Model: PRIPORT Cats-eye		Date: 20-Apr-07	No: M-C269-001
Modified Article: Options change for Cat's-eye		Prepared by: K. Yamamoto	
From: Priport Service Planning Section			
Classification:	☒ Parts catalog correction ☐ Vendor change ☐ To meet standards ☐ To facilitate assembly ☒ To improve reliability () ☐ Part standardization ☐ Other ()		
Model Name: Cat's-eye: Ricoh DX4640PD, Gestetner CP6340D, Savin 3585DNP2, Standard SD462, Lanier LDD350d

Change/Reason: The parts below were added or changed to support use with the Cat's Eye.

19.Duplex Unit 3 (C269)

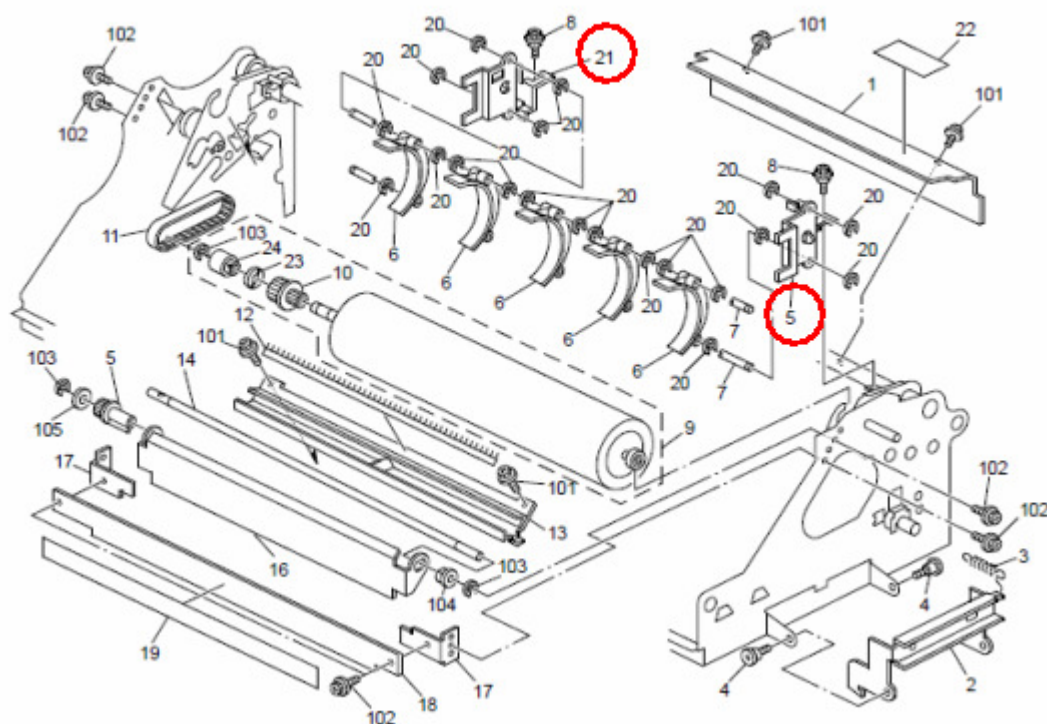
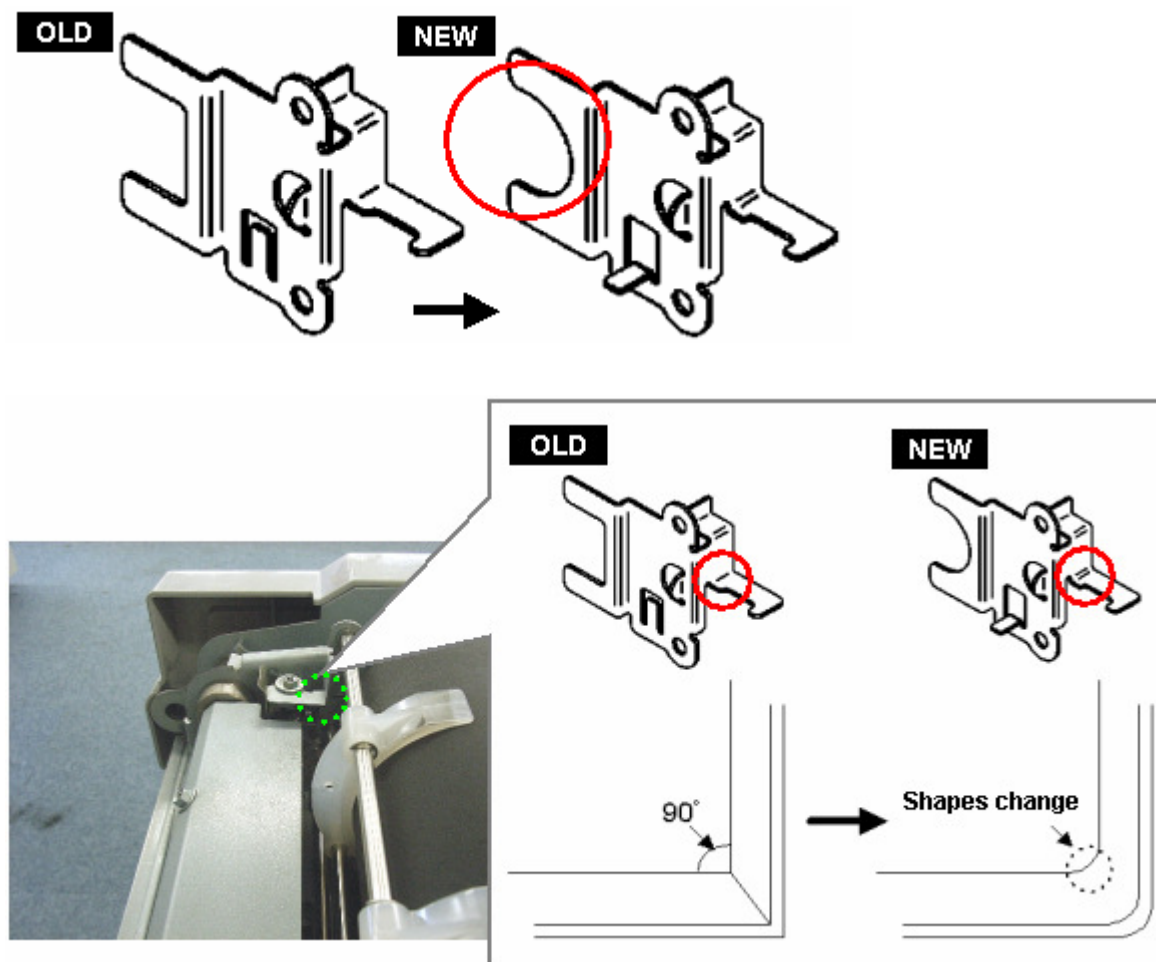
Change: The shapes of these parts were changed.

Reason: To improve the durability of these parts.

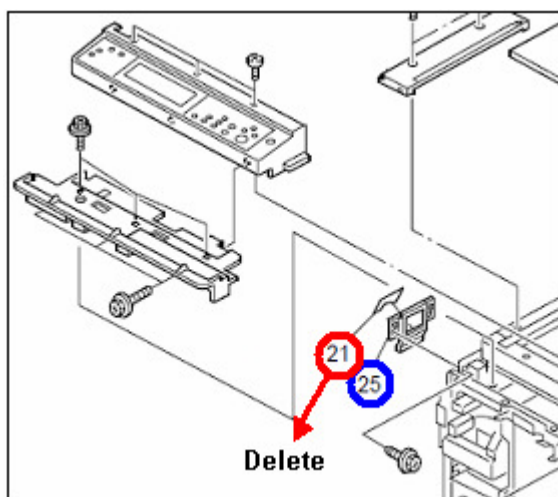
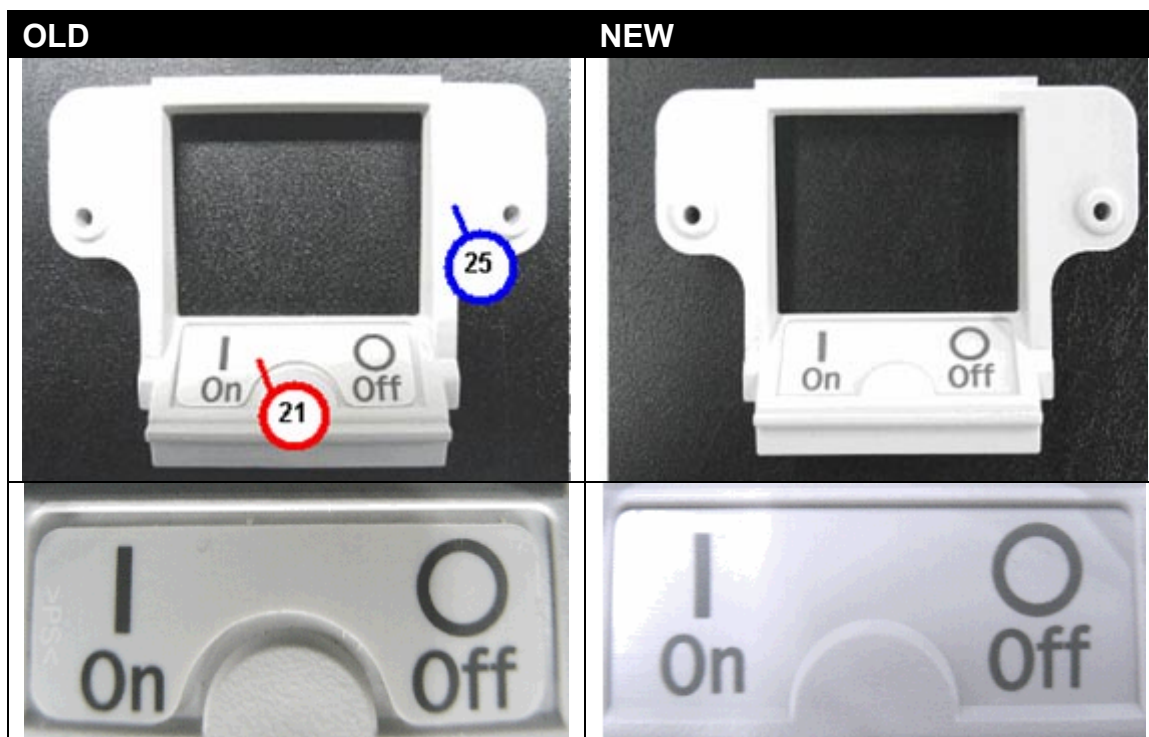
Change: The decal on the main switch cover was deleted.

Reason: The content of the decal is print directly on the main switch cover.

Note: This change does not apply to the **C269-53**.

1.EXTERIOR (C651)

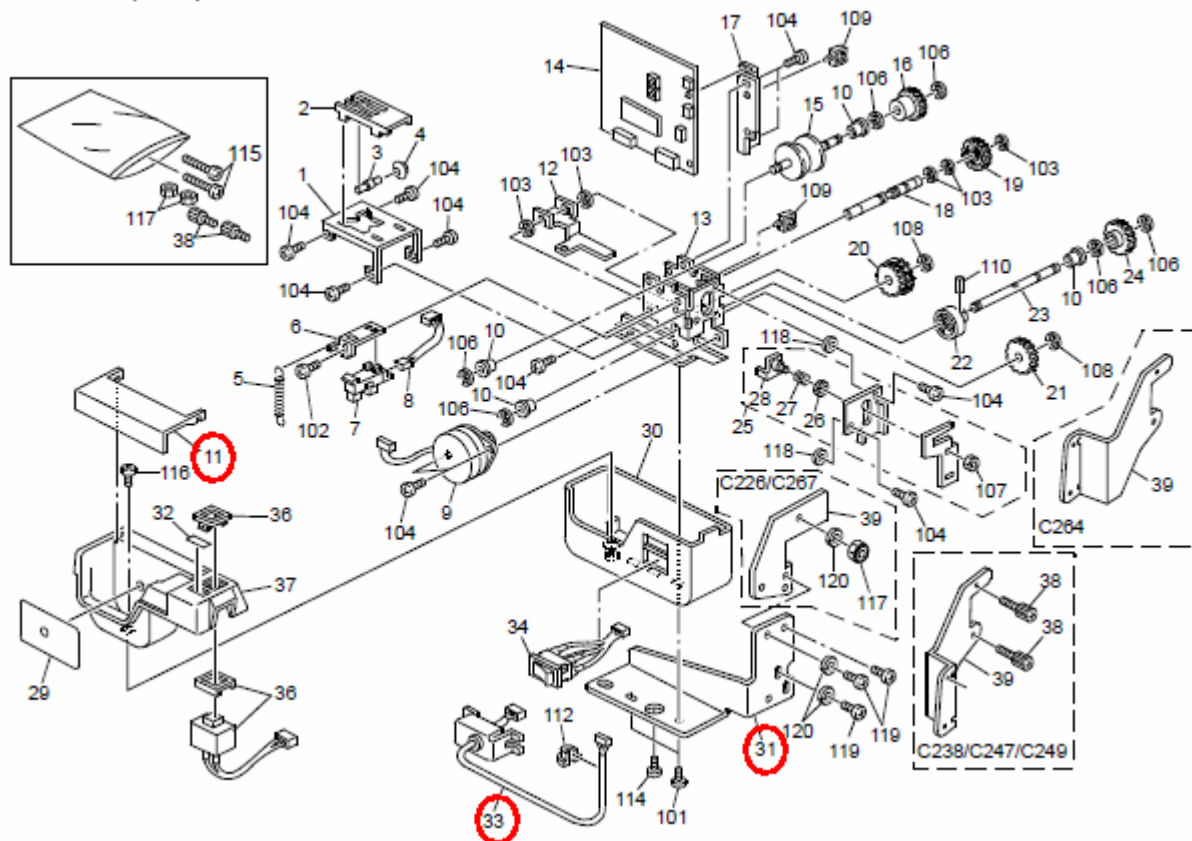
Change/Reason: Vendor change.

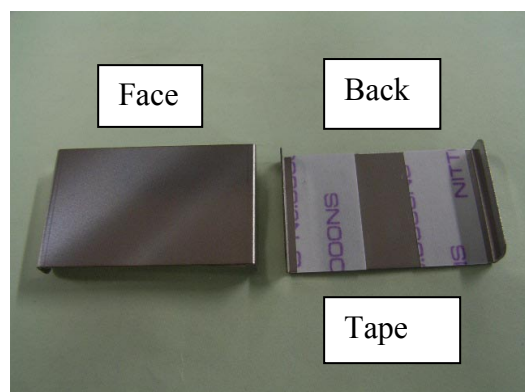
Change: Covers for the master eject rollers were added.

Reason: To ensure the ejected master moves more smoothly along the master eject roller.
